Request For Information RFI-097

Subject: BP3 Art and Brand Wall Supplemental Steel
Project: Steamboat - BV BP Promenade and Goldwalk
Address: 2305 Mount Werner Circle
Steamboat Springs CO 80487 USA
Phone:
To: Bryan Sculthorpe
Saunders Construction, LLC
From: Saunders Construction, LLC

Ref attached correspondence and bootleg drawings sheets, the supplemental steel for the Goldwalk and Artwall is required to be included in BP3 Goldwalk scope.

GOLD WALK - LIGHTING PLAN - LEVEL 01

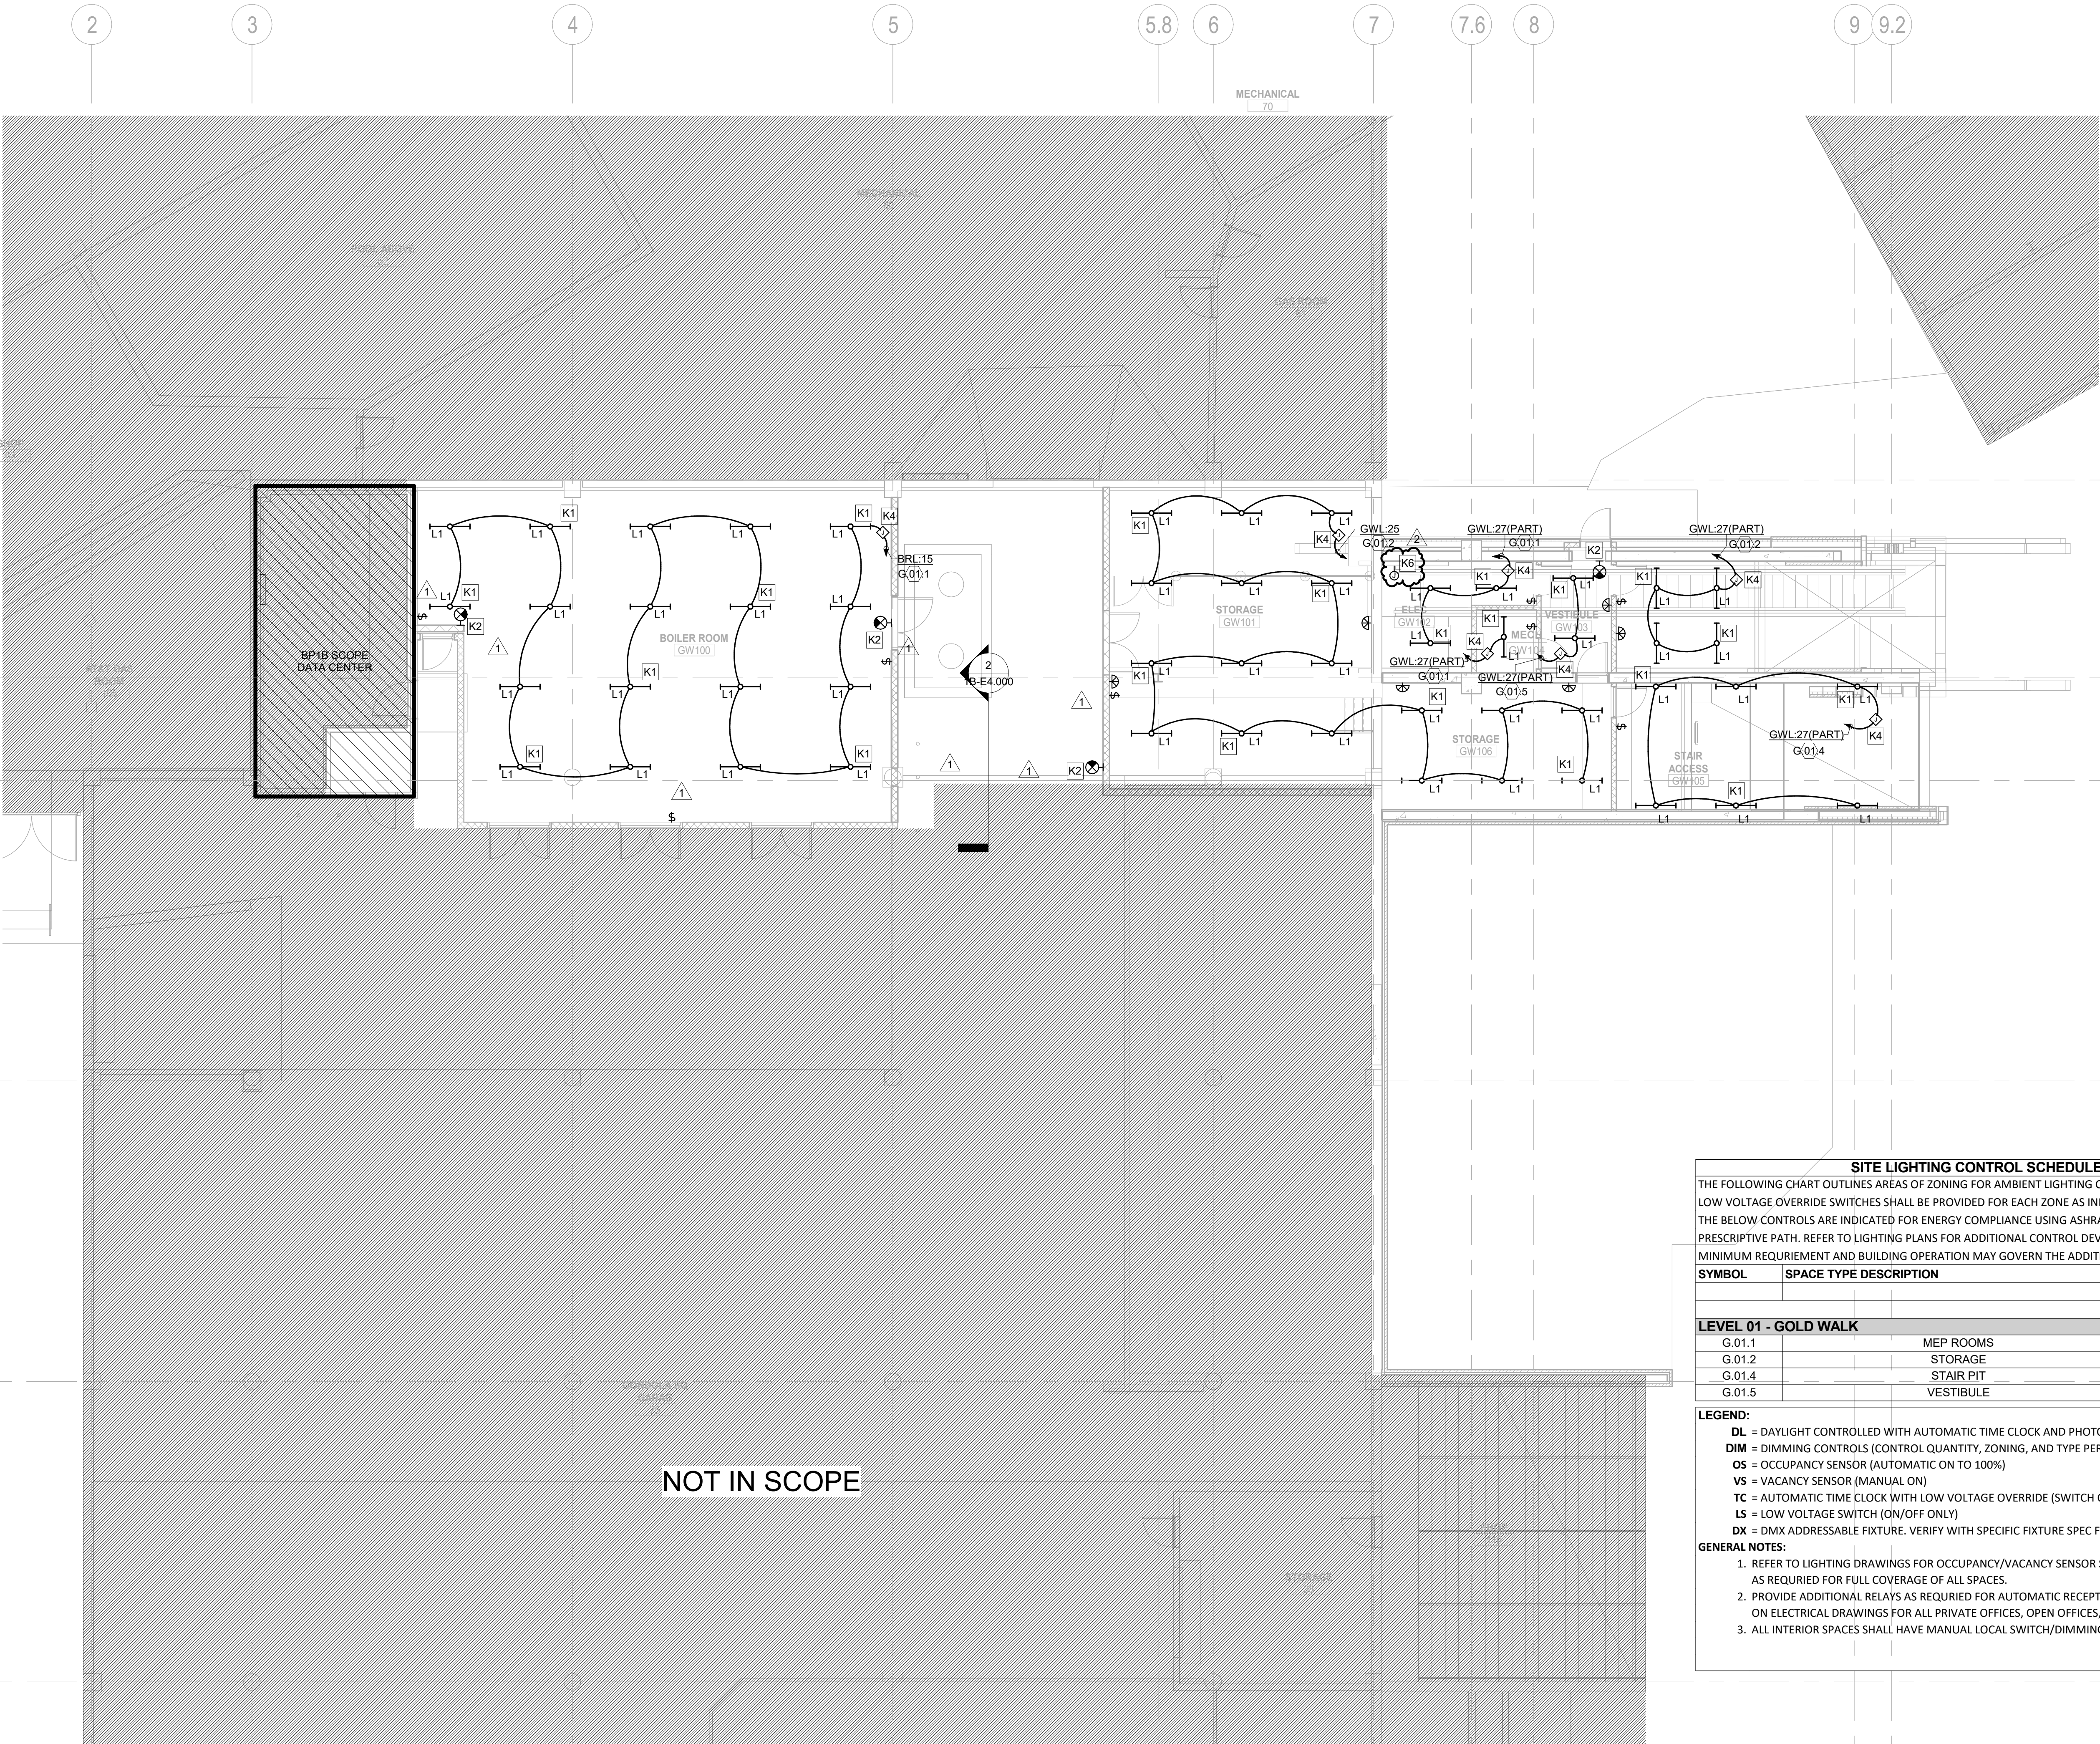
IN ADDITION TO THE STEEL QUESTION ABOVE, CIRCUITING AND CONTROL INFORMATION HAS BEEN PROVIDED IN THE ATTACHED DRAWING UPDATE FOR ADDED LIGHTING WITHIN THE ART WALL AND BRAND WALL. REFER TO ADDITIONAL CORRESPONDENCE (PAGES 7-21 HEREIN) FOR FIELD COORDINATION AND INSTALLATION CLARIFICATIONS. EXACT DMX CONTROL SYSTEM SHALL BE CONFIRMED BASED ON THE LIMITATIONS OF THE BASIS OF DESIGN DMX CONTROLLER AND THE OWNER DESIRED DYNAMIC SCENE EFFECTS THAT ARE TO OCCUR AT THESE WALLS. FURTHER CONFIRMATION FROM OWNER AND LIGHTING CONTROLS PROGRAMMER REQUIRED PRIOR TO FINAL DMX SYSTEM SELECTION.
ACJ/ME 10.01.2021

K6 POWER SUPPLY AND DATA INJECTOR ASSOCIATED WITH F6 LIGHT FIXTURE AT ART WALL AND BRAND WALL TO BE LOCATED IN ACCESSIBLE LOCATION WITHIN THIS ROOM. REFER TO SITE LIGHTING PLAN AND LIGHTING DESIGNER PLANS FOR ADDITIONAL INFORMATION.

2/Z50.1: ART WALL DETAIL - EAST ✓

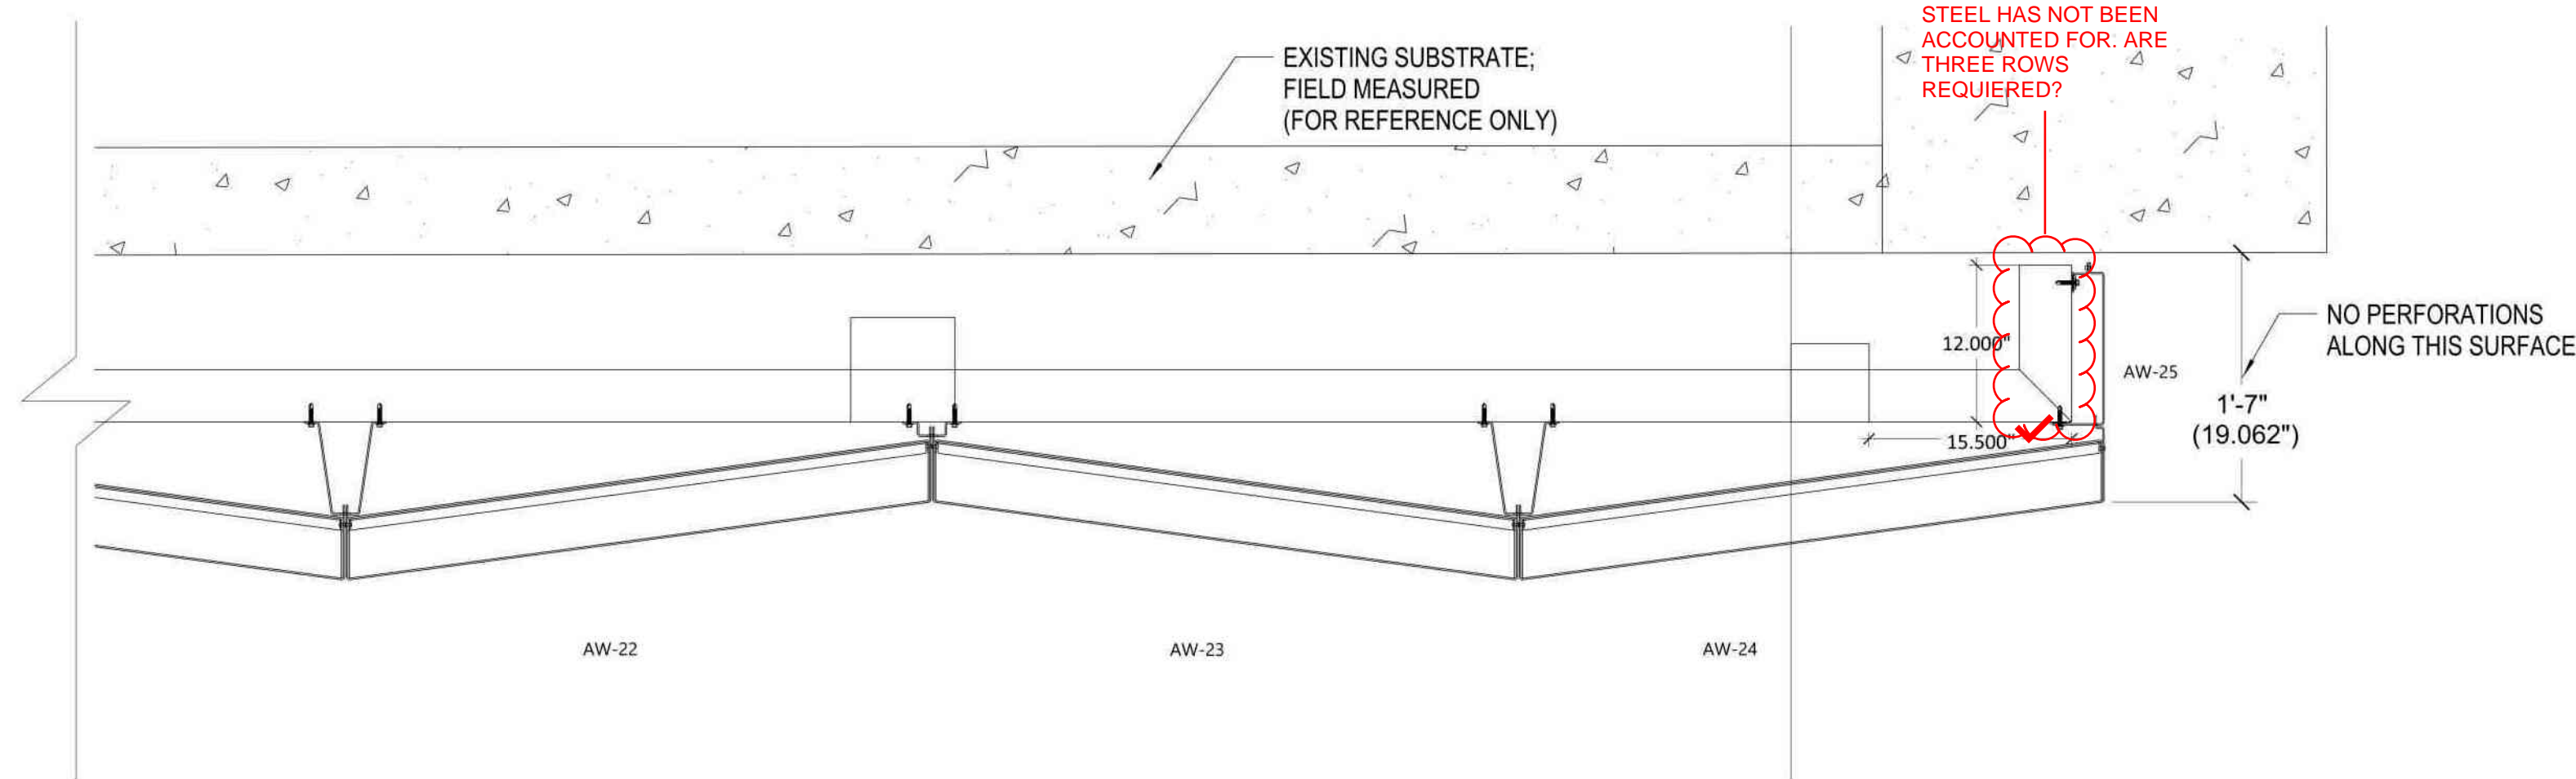
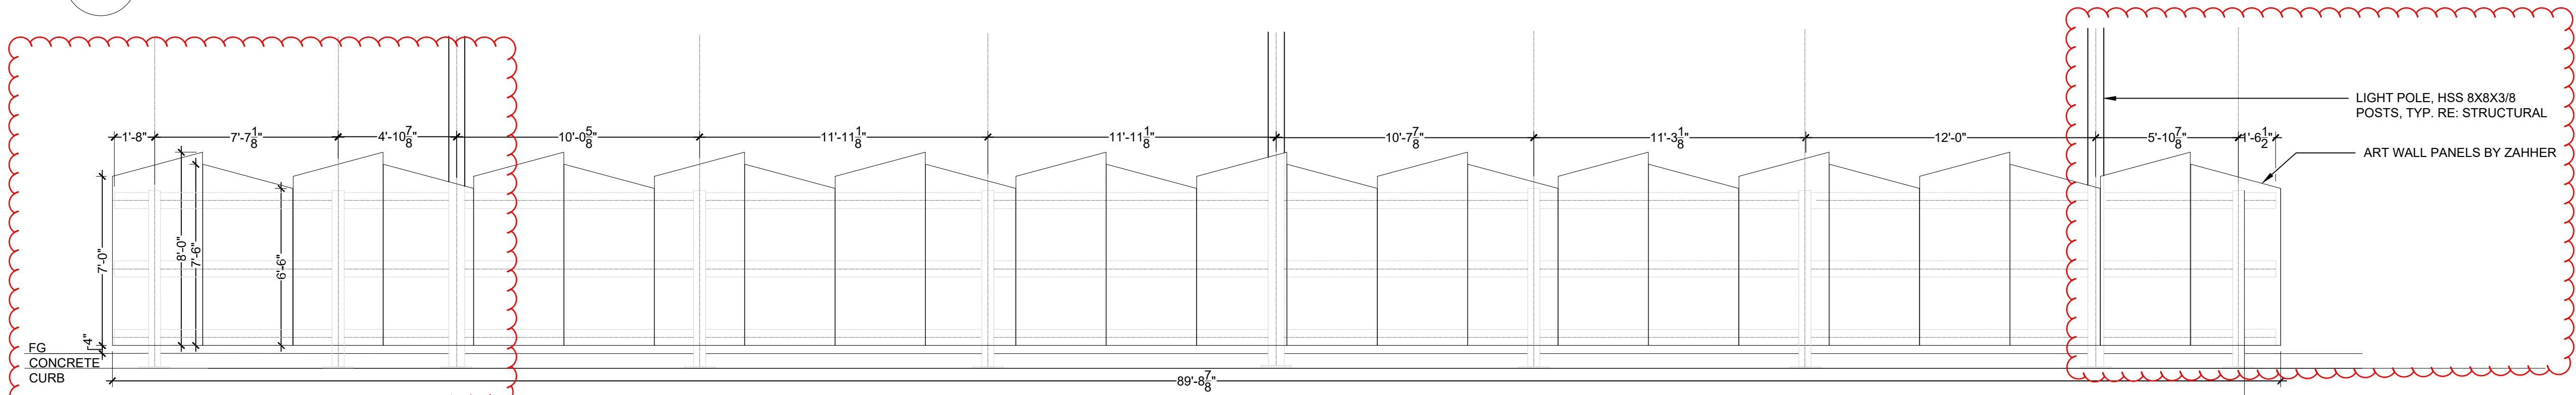
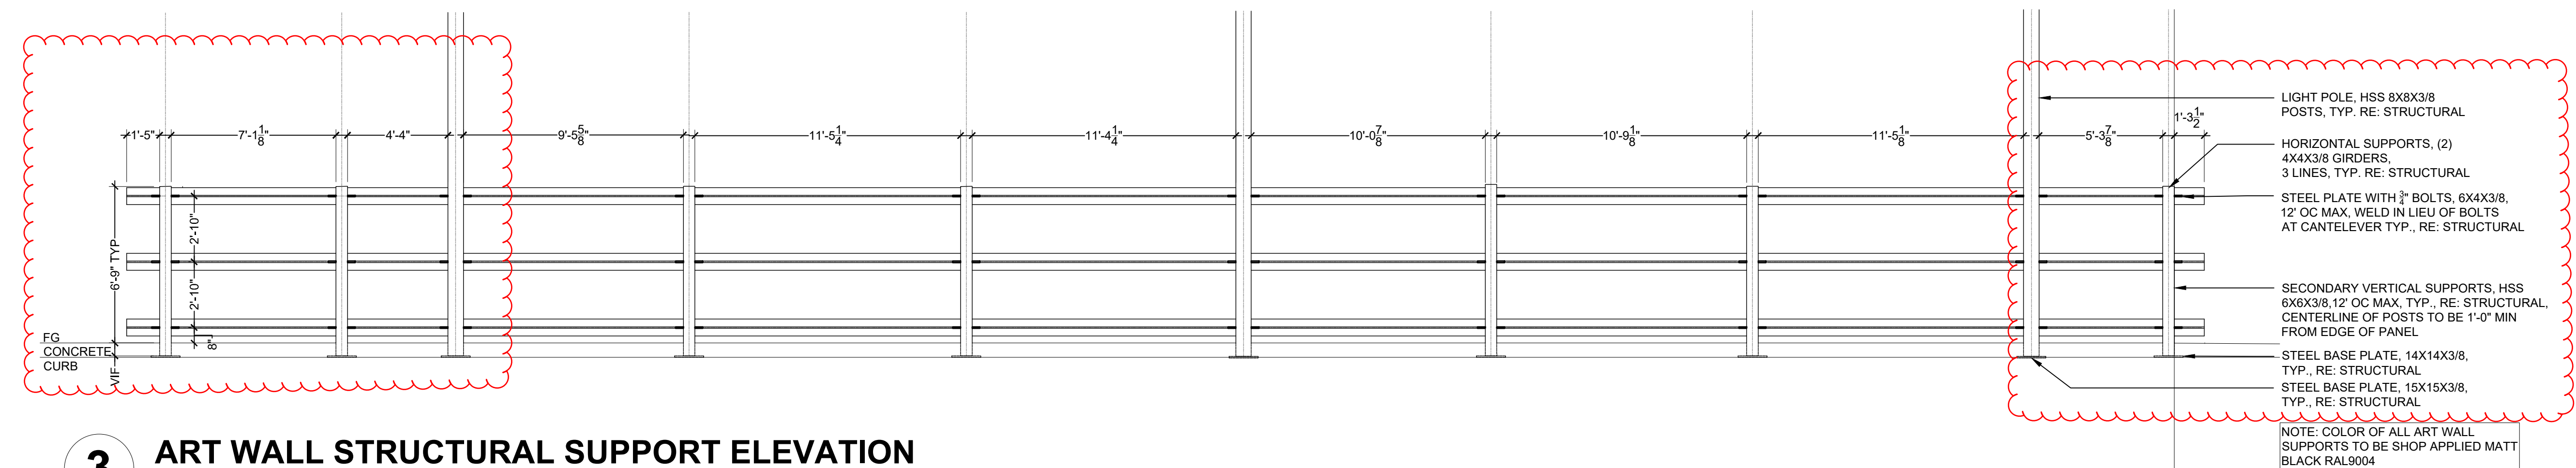
ABE, PLEASE SEE ZAHNER SHOP DRAWING TO LEFT. THIS IS THE EAST END OF THE ART WALL. WE WILL NEED TO PROVIDE GIRTERS FOR THIS END CAP. ANY CONCERNS?

No concern.
(CAC, M/M)
